The Commission has issued the enclosed Amendments Nos. 113, 113, and 110 to Licenses Nos. DPR-38, DPR-47 and DPR-55 for the Oconee Nuclear Station, Units Nos. 1, 2 and 3. These amendments consist of changes to the Station's common Technical Specifications (TSs) in response to your request dated May 3, 1982, as revised in its entirety by letter dated August 11, 1982, and supplemented by letter dated August 16, 1982.

These amendments revise the TSs to allow full power operation of Oconee Unit 3 during fuel Cycle 7.

ATTACHMENTS TO LICENSE AMENDMENTS

SAFETY EVALUATION BY THE OFFICE OF NUCLEAR REACTOR REGULATION  
SUPPORTING AMENDMENT NO. 113 TO FACILITY OPERATING LICENSE NO. DPR-38

Figure 2.1-2C

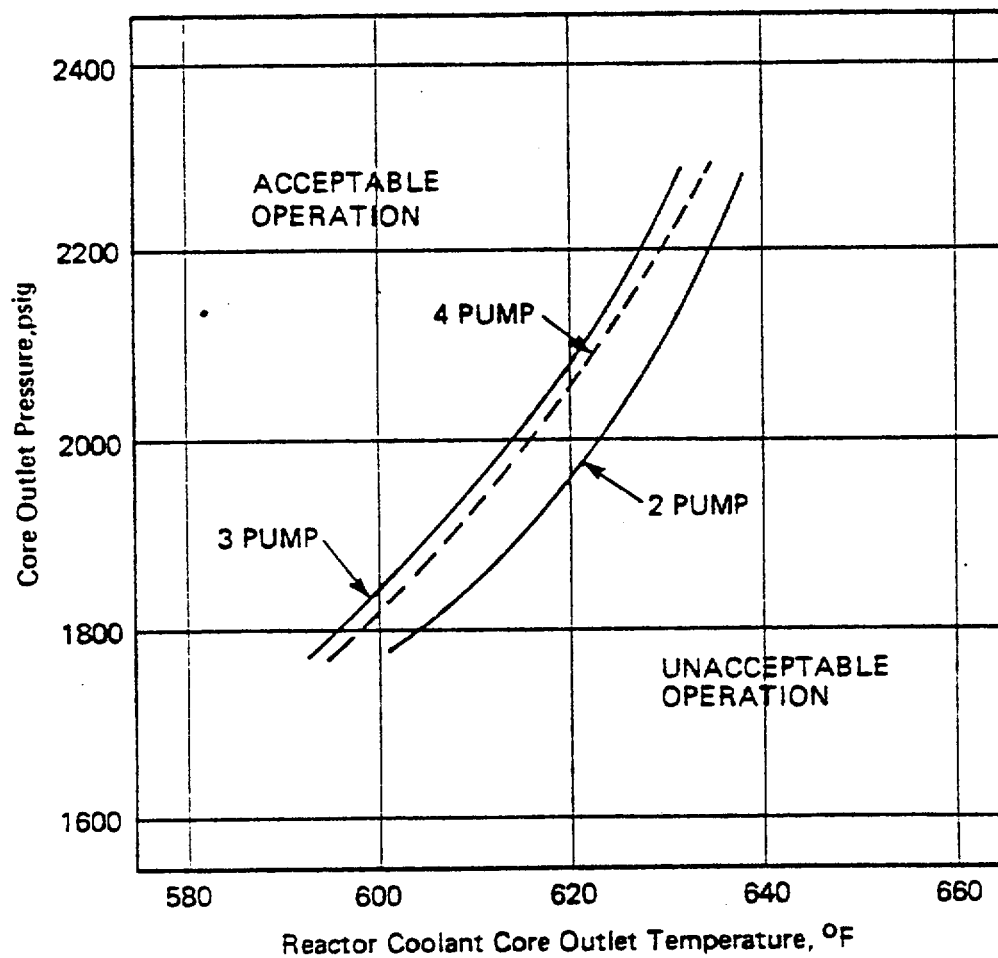
We have reviewed the proposed TS revisions for Cycle 7. These changes concern the (1) Core Protection Safety Limits of Specification 2.1; (2) Protective System Maximum Allowable Setpoints of Specification 2.3; and (3) Rod Position Limits of Specification 2.5.2. The limiting safety system settings and the limiting condition for operation have been established by approved methods. Changes which reflect the core thermal-hydraulic response still maintain the safety limit Departure from Nucleate Boiling Ratio (DNBR) criterion of 1.30. The control rod withdrawal limits for the various pump combinations and times in core life are presented as well as part length axial power shaping rod position limits. On the basis that previously

2. The combination of radial and axial peak that causes central fuel melting at the hot spot. The limits for Unit 3 are 20.5 kw/ft for fuel rod burn-up less than or equal to 10,000 MWD/MTU and 21.5 kw/ft - after 10,000 MWD/MTU.

Figure 3.5.2-1C1

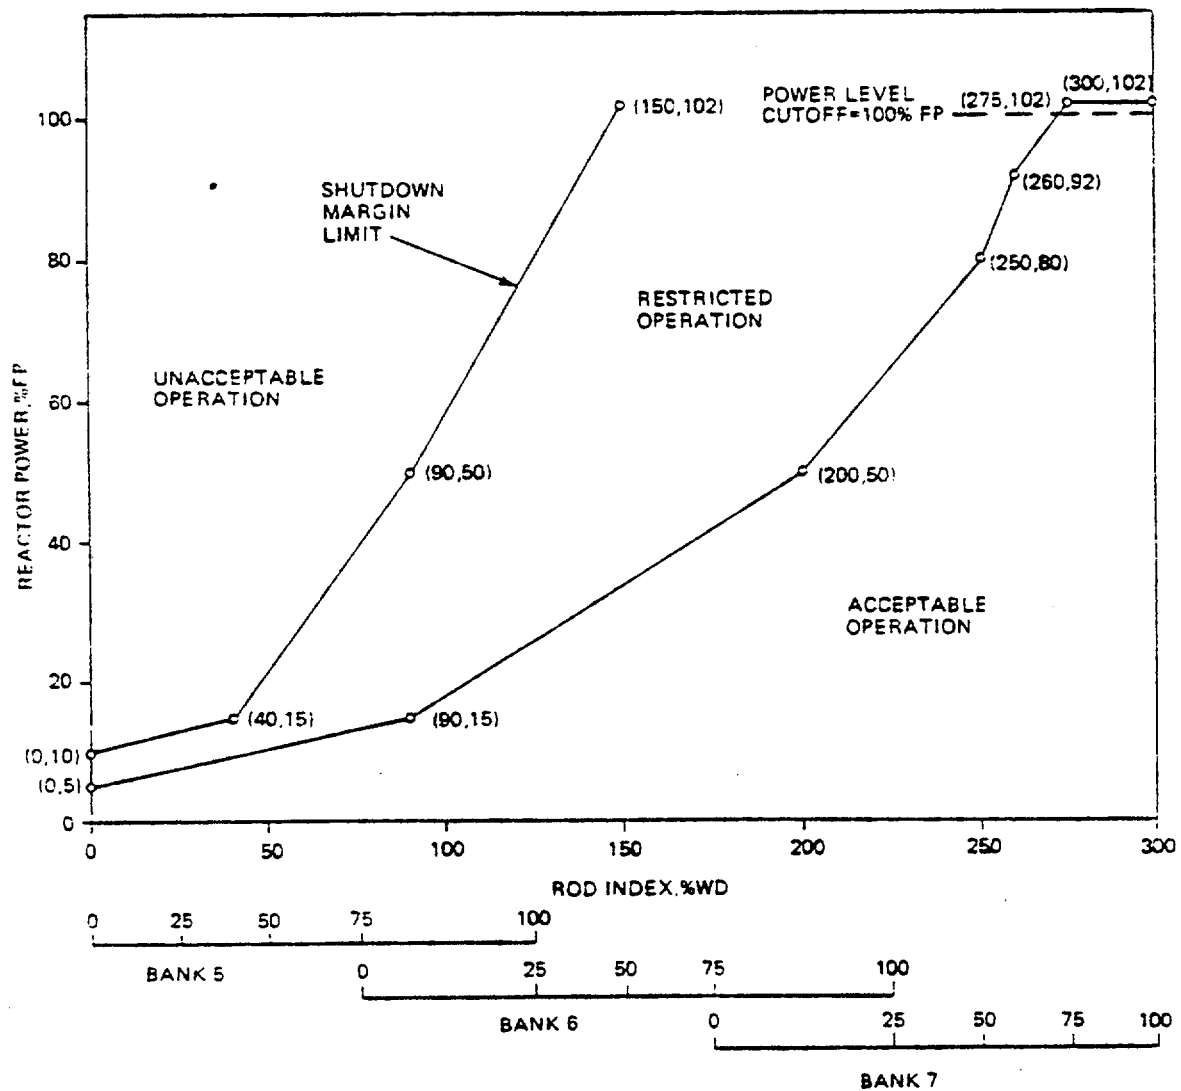
- c. Position limits are specified for regulating and axial power shaping control rods. Except for physics tests or exercising control rods, the regulating control rod insertion/withdrawal limits are specified on figures 3.5.2-1A1, 3.5.2-1A2, and 3.5.2-1A3 (Unit 1); 3.5.2-1B1, 3.5.2-1B2, and 3.5.2-1B3 (Unit 2); 3.5.2-1C1, 3.5.2-1C2, and 3.5.2-1C3 (Unit 3) for four pump operation, on figures 3.5.2-2A1, 3.5.2-2A2, and 3.5.2-2A3 (Unit 1); 3.5.2-2B1, 3.5.2-2B2, and 3.5.2-2B3 (Unit 2); figures 3.5.2-2C1, 3.5.2-2C2, and 3.5.2-2C3 (Unit 3) for three pump operation, and on figures 3.5.2-2A4, 3.5.2-2A5, and 3.5.2-2A6 (Unit 1); 3.5.2-2B4, 3.5.2-2B5, and 3.5.2-2B6 (Unit 2); figures 3.5.2-2C4, 3.5.2-2C5, and 3.5.2-2C6 (Unit 3) for two pump operation. Also, excepting physics tests or exercising control rods, the axial power shaping control rod insertion/withdrawal limits are specified on figures 3.5.2-4A1, 3.5.2-4A2, and 3.5.2-4A3 (Unit 1); 3.5.2-4B1, 3.5.2-4B2, and 3.5.2-4B3 (Unit 2); 3.5.2-4C1, 3.5.2-4C2, and 3.5.2-4C3 (Unit 3).

ROD POSITION LIMITS  
FOR FOUR-PUMP OPERATION  
FROM 0 TO 50 (+10, -0) EFPD  
UNIT 3
